DART AEROSPACE LTD		Work Order:	76106
Description: Crosstube Assembly (412 High Aft)		Part Number:	D412-664-243
Inspection Dwg: D412-664-243 Rev: E		Page 1 of 1

DRAWING NO. D412-664-243	TITLE CROSSTUBE ASSEMBLY (412 HI AFT)	REV. E	DART AEROSPACE LTD ENGINEERING ORDER		D.E.O. NO. D412-664-243-E-1	SHEET NO. SHEET 1 OF 2	SCALE NTS
DRAWN	CHECKED	MFG. APPR.	APPROVED	DE APPR.			
DATE 11.03.31	DATE 11/03/31	DATE 11.03.31	DATE 11/03/31	DATE 11.03.31

DRAWING NO. D412-664-243	TITLE CROSSTUBE ASS'Y (412 HI AFT)	REV. E	DART AEROSPACE LTD ENGINEERING ORDER		D.E.O. NO. D412-664-243-E-2	SHEET NO. SHEET 1 OF 1	SCALE NTS
DRAWN MP	CHECKED NS	MFG. APPR. E	APPROVED MP		DE APPR. H		
DATE 11.09.07	DATE 11.09.19	DATE 11.09.19	DATE 11.09.19		DATE 11.09.19

D212-664-243
ASSEMBLY DETAIL

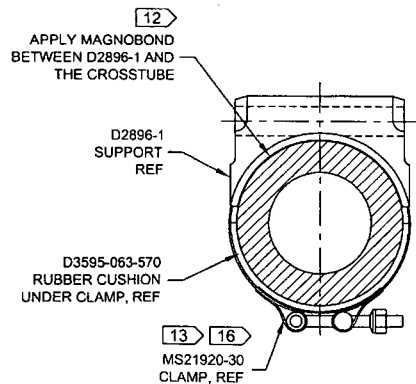
PURPOSE:

REMOVED ABRASION STRIP IN FAVOR OF A THIN LAYER OF PROSEAL 890.

IS:

D3189-1 CHAFING SHIELD (1, INSTALLED OVER PROSEAL 890)
MS21920-28 CLAMP, 2X
2 PL

WAS:

D2856-600-1009 ABRASION STRIP
D3189-1 CHAFING SHIELD (1, INSTALLED OVER ABRASION STRIP)
MS21920-28 CLAMP, 2X
2 PL

MASK AREA PRIOR TO PAINTING AND
APPLY CLEAR COAT AFTER PAINTING
